IMPORTANT SAFETY RECALL NOTICE

NHTSA Recall Number: 16V-542 School Bus
NHTSTA Recall Number: 16V-543 Non-School Bus

Subject: RECALL R16YT, Propane Fuel Line Routing

**Models Affected: Certain 2015 through 2017 Model Year Vision Buses
Equipped with Propane Engines**

ISSUE

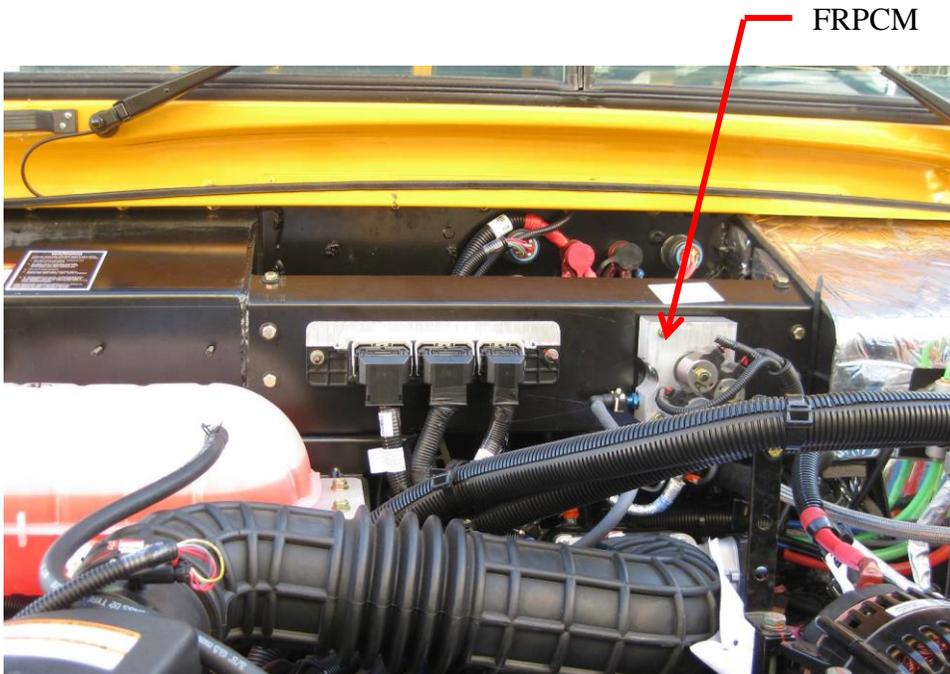
Propane fuel lines may be crossed and/or rubbing. Crossed and/or rubbing fuel lines may become damaged from movement and develop a leak.

Inspect fuel lines and if necessary reroute propane fuel lines to ensure the lines are secured parallel and are not rubbing. Replace any damaged fuel line(s).

INSPECT FUEL LINE ROUTING BELOW FRPCM

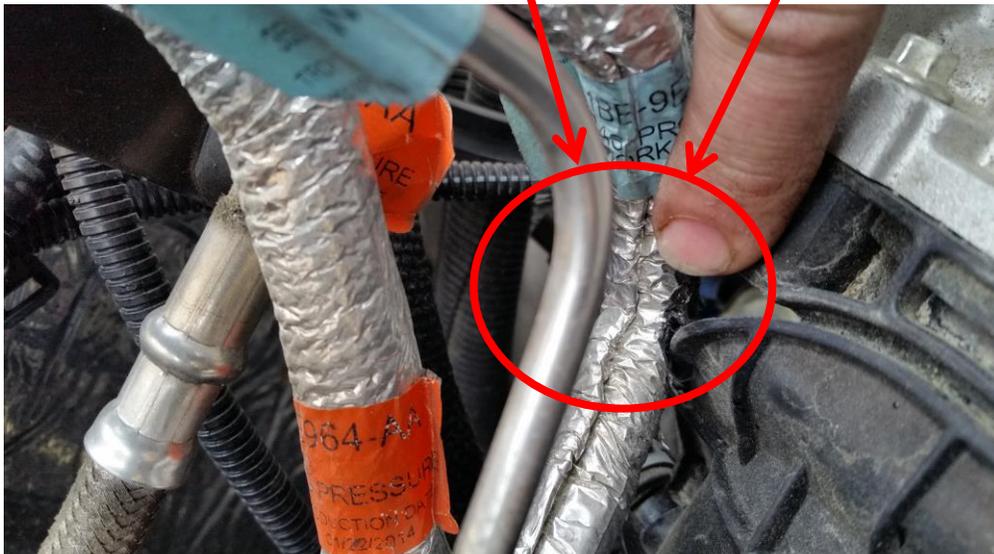
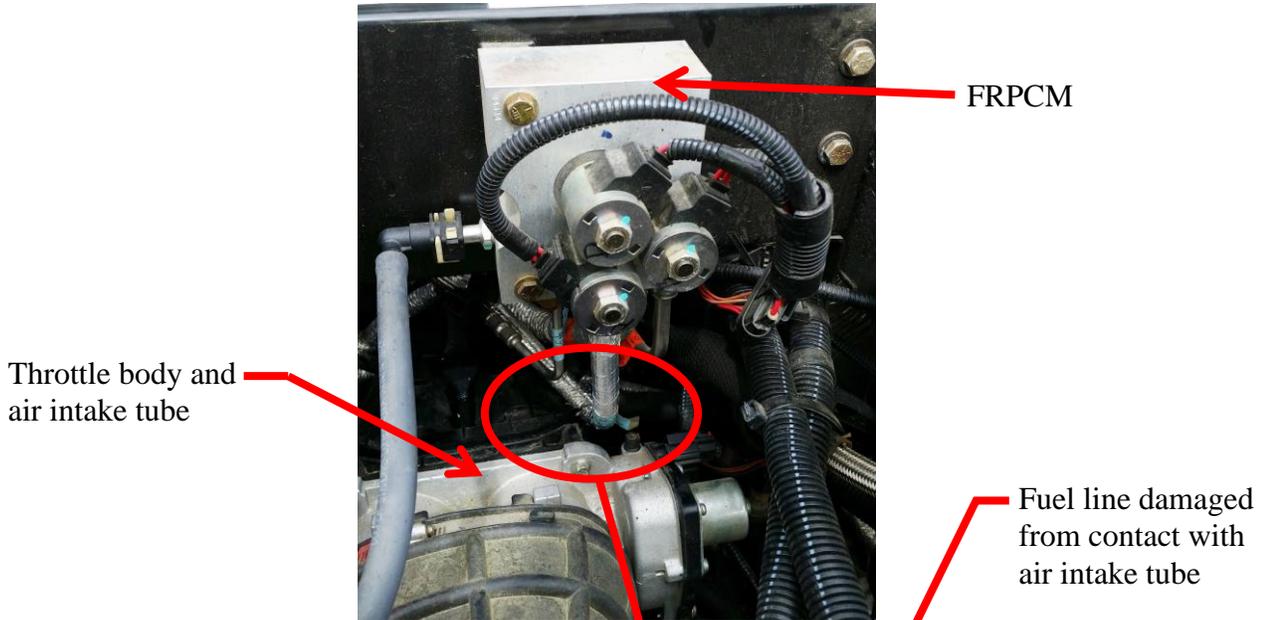
4. Inspect for clearance between the fuel lines and the air intake tube.
5. If the fuel lines are contacting the air intake tube, inspect for damage to the fuel lines and follow reroute instructions.

Photo 1
(Viewed from front of engine)

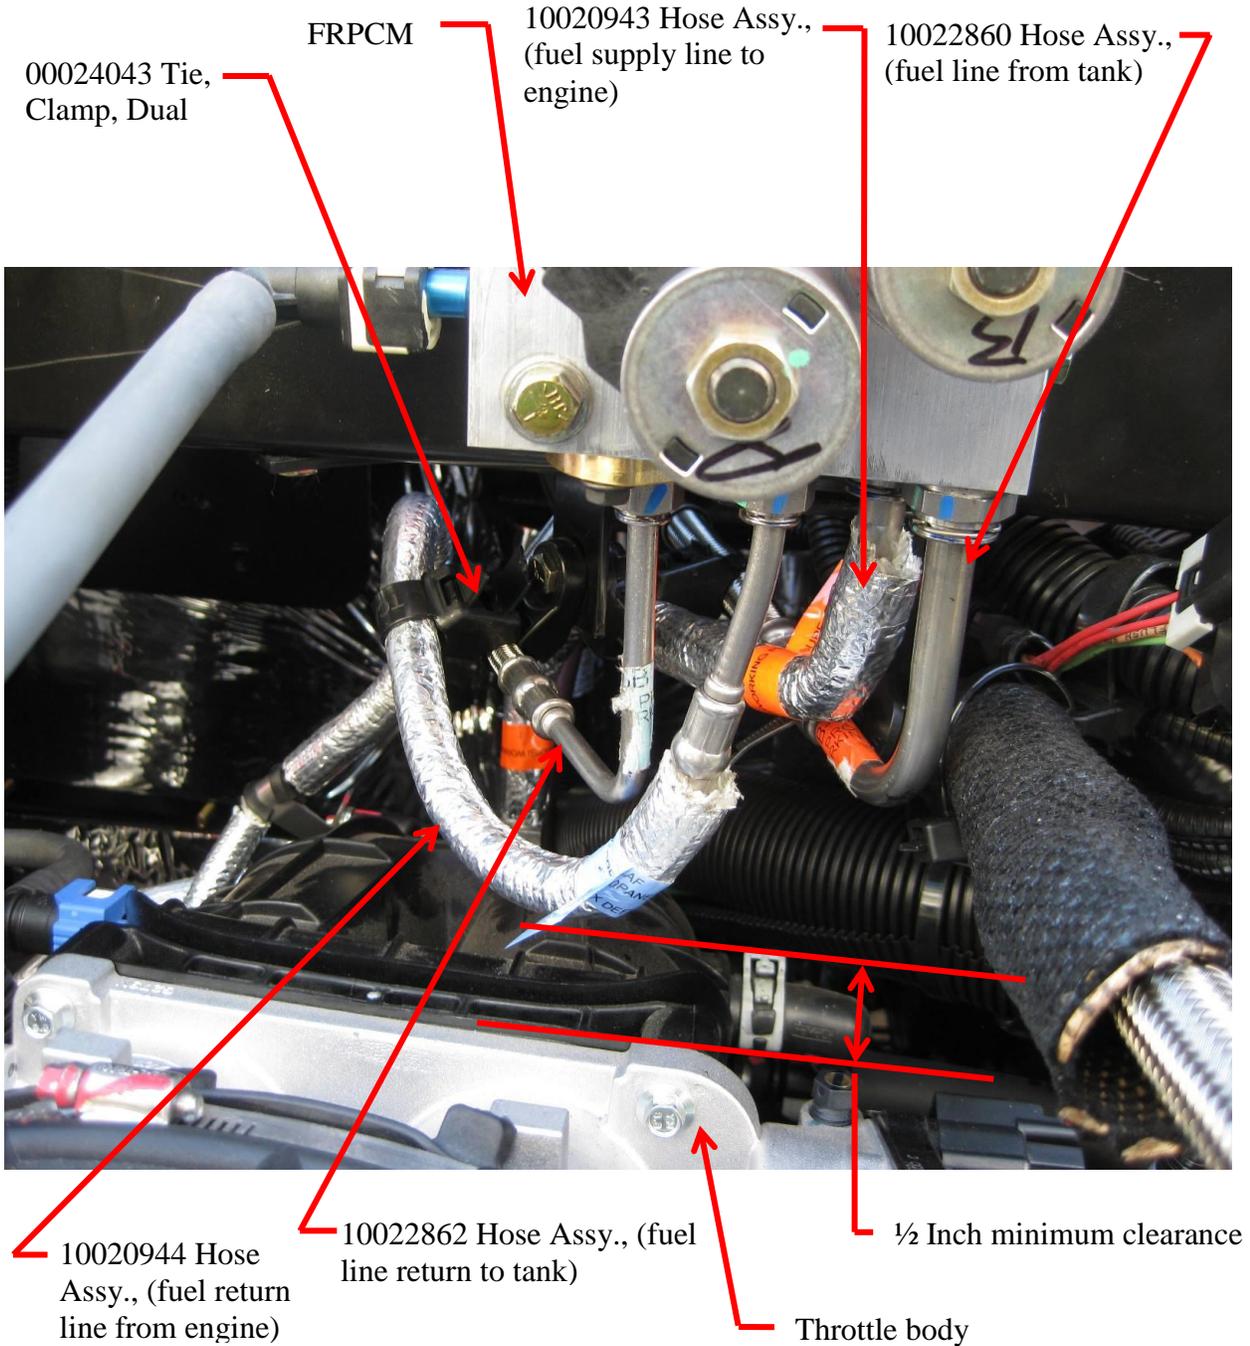
5. Using Photo's 1, 2, 3, and 4 in the **Proper Routing and Clamping Section** as your guide, reroute the four fuel lines to be parallel with each other. Install two or three dual clamp ties Part Number 00024043 to maintain separation.

- b. **Be sure to follow ALL of the Warnings and Cautions in the propane section of Blue Bird Service Manual.**
6. Maintain 1/2 inch minimum clearance between the throttle body/air intake tube and the bottom of the fuel lines (See Photo 1).

Photo 2
(Viewed looking down on top of engine with air brakes)

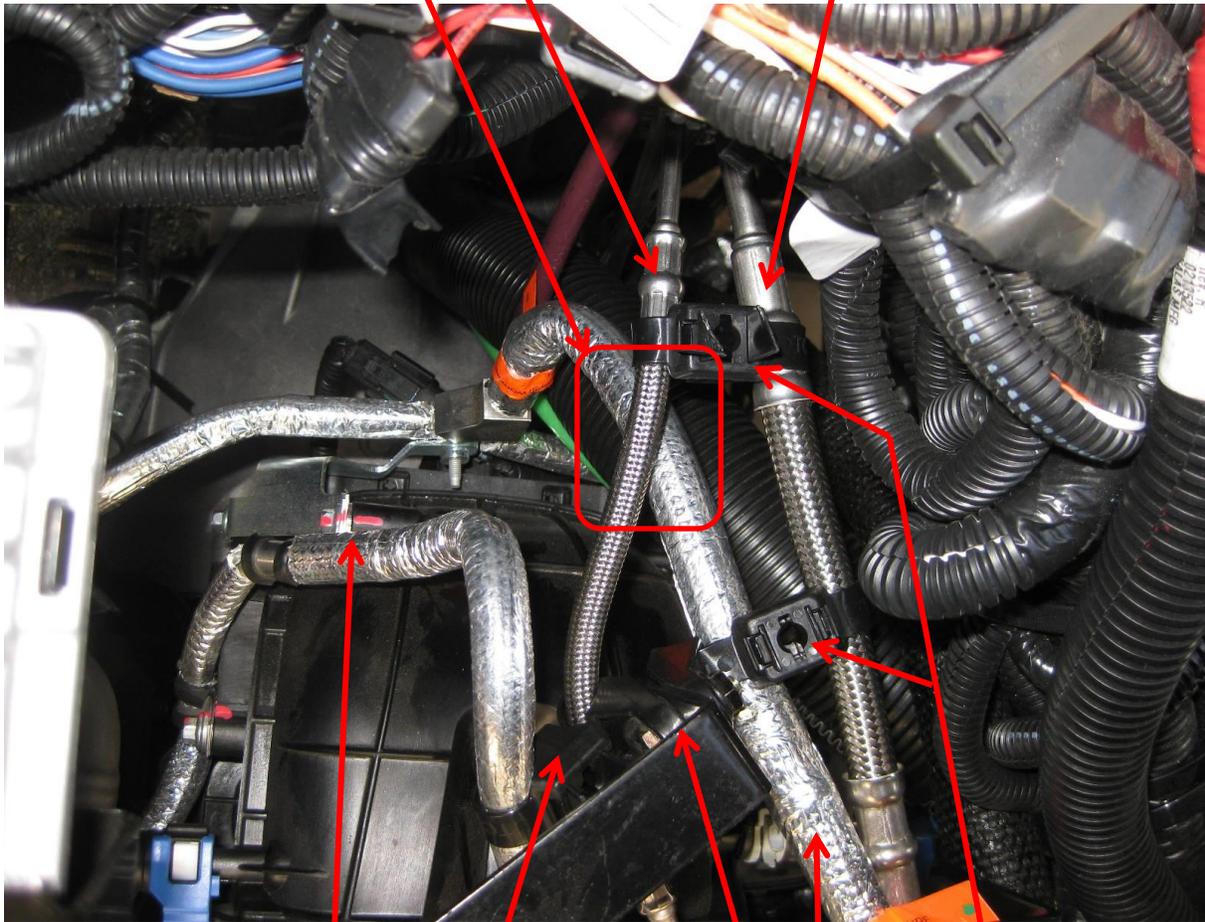
Note: Ensure there is a minimum of 1/2 inch clearance between hoses.
